RE: **PETITION NO. 1487** – TRITEC Americas, LLC petition for a declaratory ruling, pursuant to Connecticut General Statutes §4-176 and §16-50k, for the proposed construction, maintenance and operation of a 1.97-megawatt AC solar photovoltaic electric generating facility located at 254 Putnam Road, Pomfret, Connecticut, and associated electrical interconnection.

**Petition No. 1487
TRITEC Americas, LLC
Pomfret, Connecticut
Interrogatories**

Attachment B: Revised Site Plan

5 **CHAIN-LINK FENCE & GATE DETAIL**
SCALE : N.T.S.

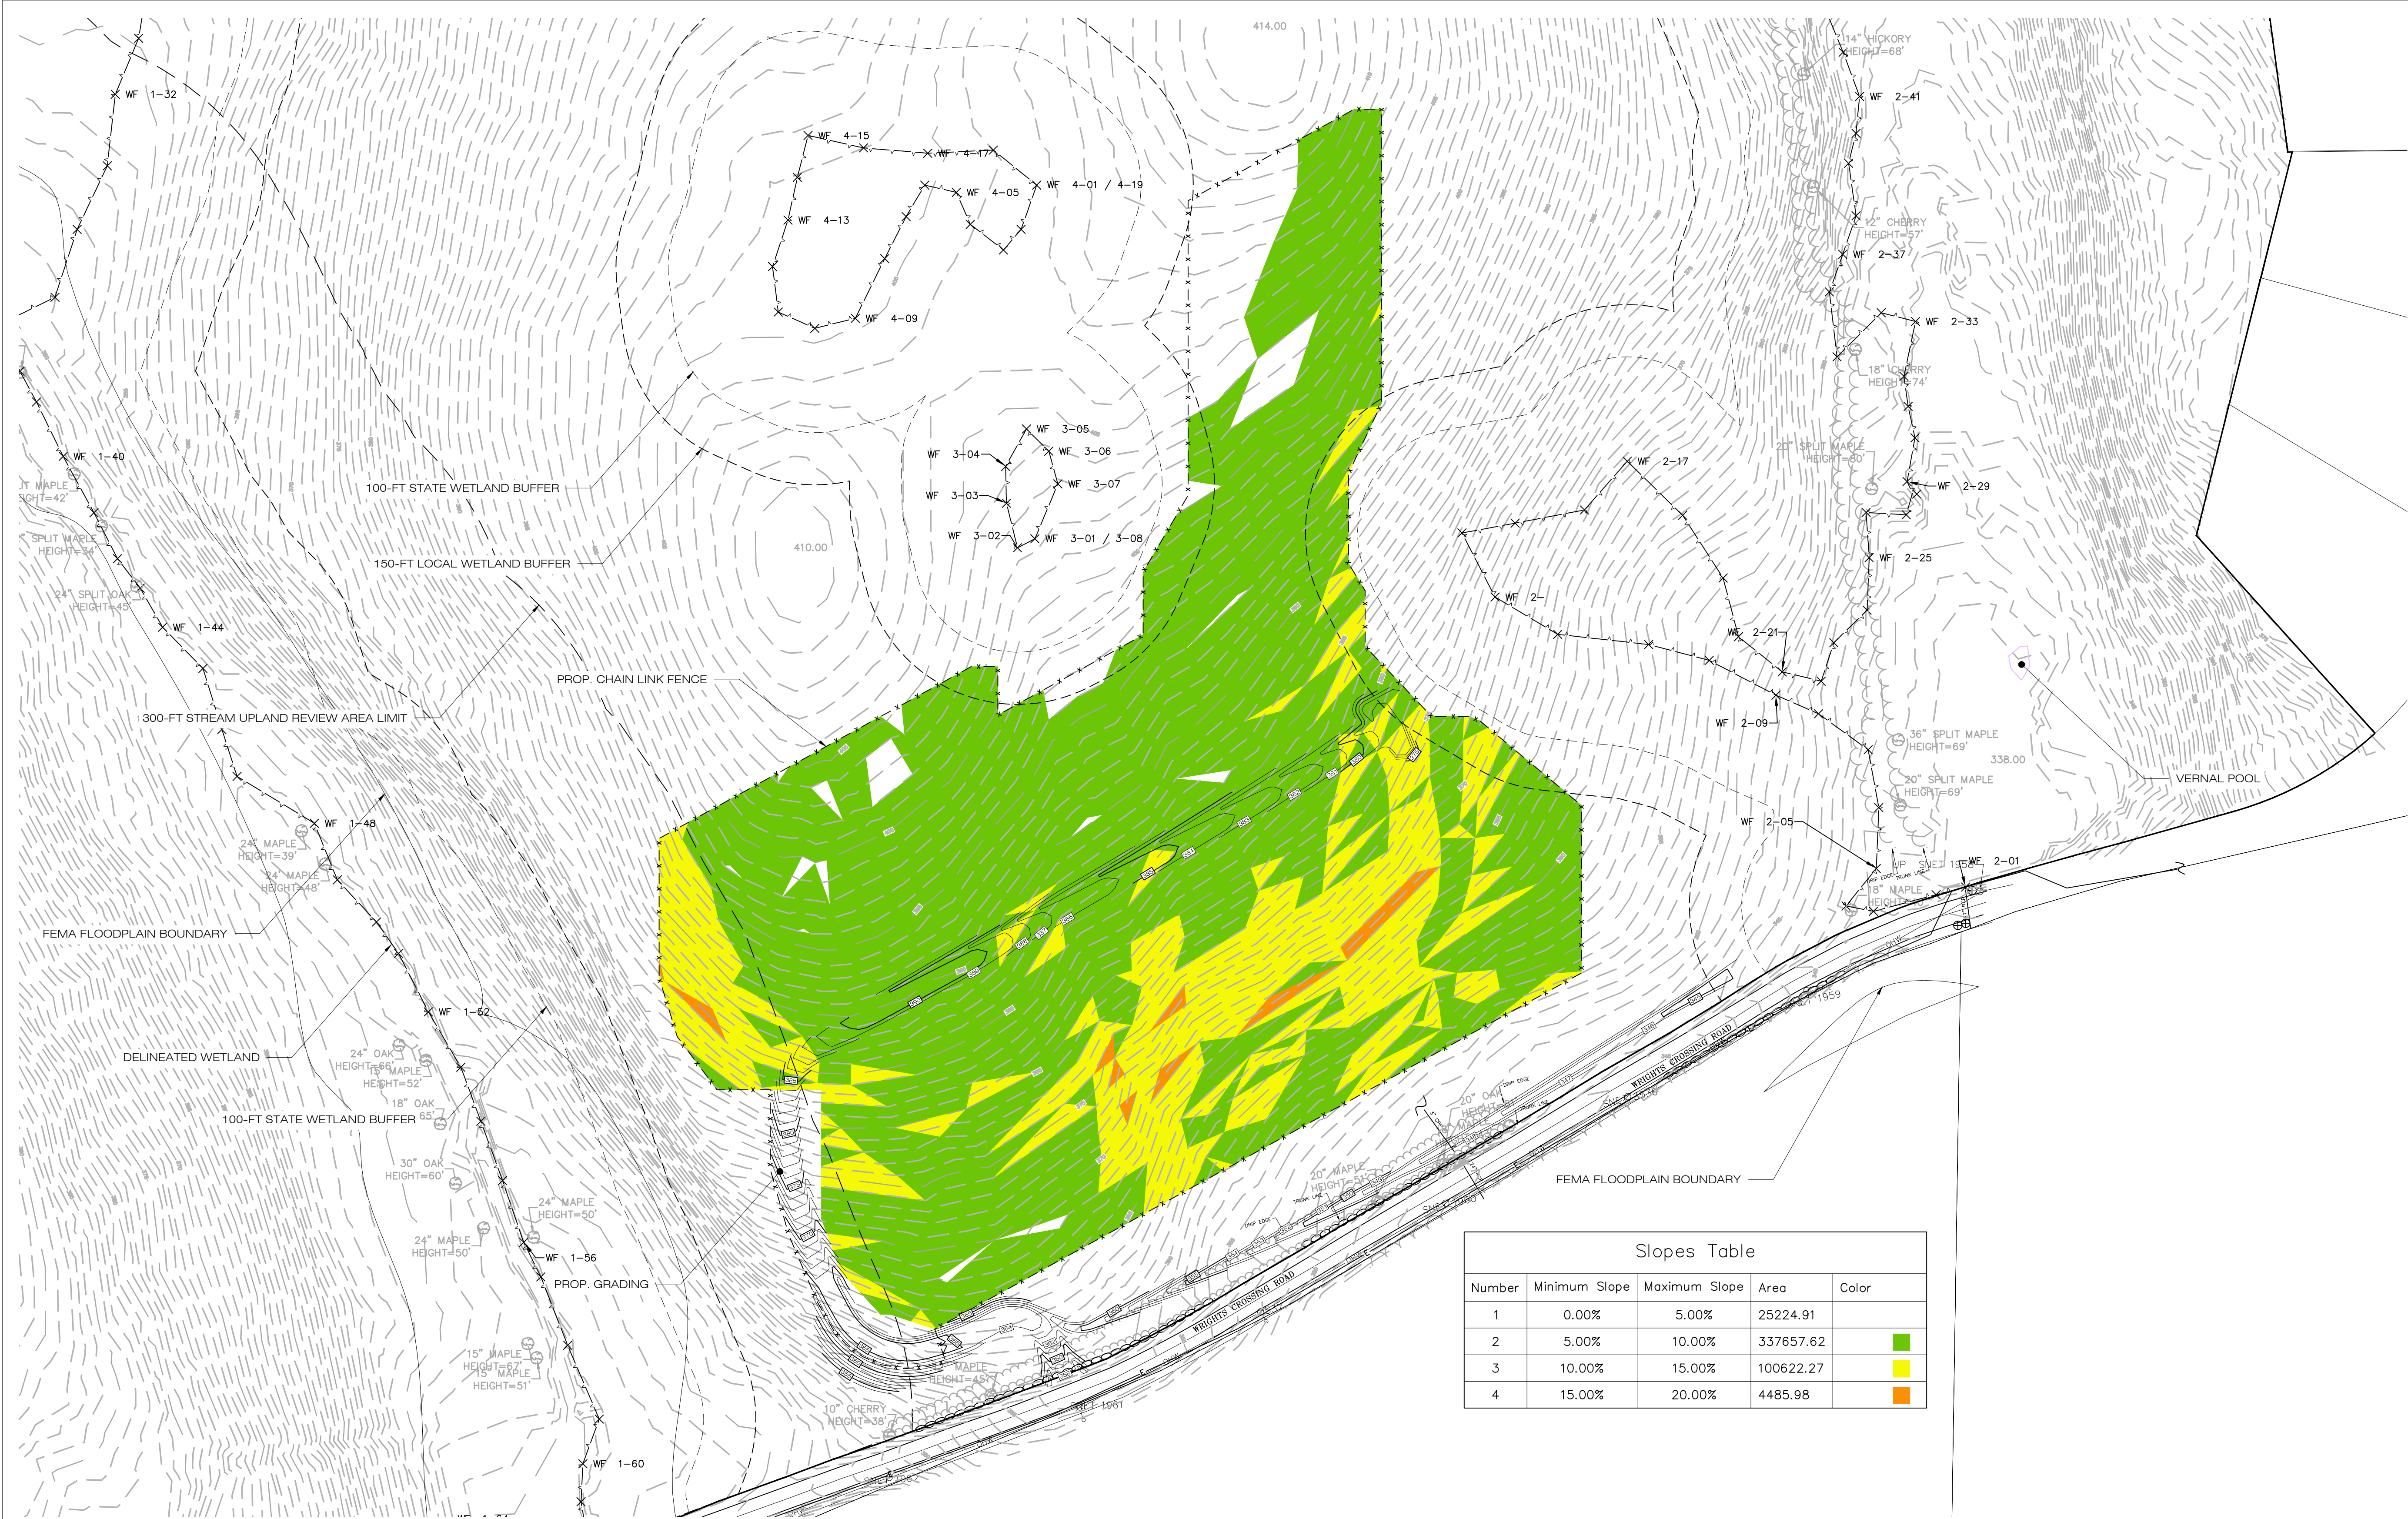
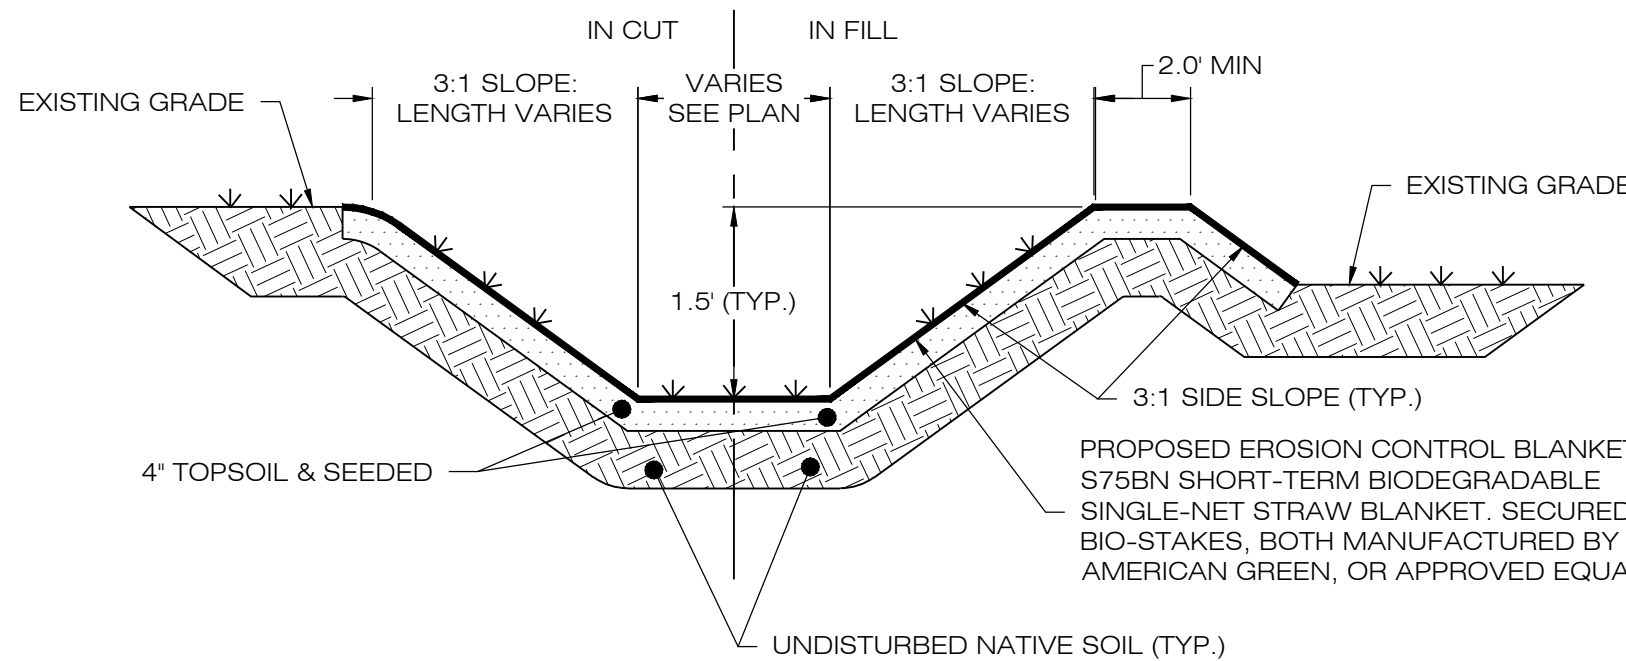
17. Site Plan DN-1 specifies a six-foot high chain link fence. Revise the plan to include a seven-foot-high chain link fence, as referenced on Petition p. 8.

See attached for a revised Site Plan which includes the update to a seven-foot-high chain link fence as depicted on Sheet DN-1. Attachment B.
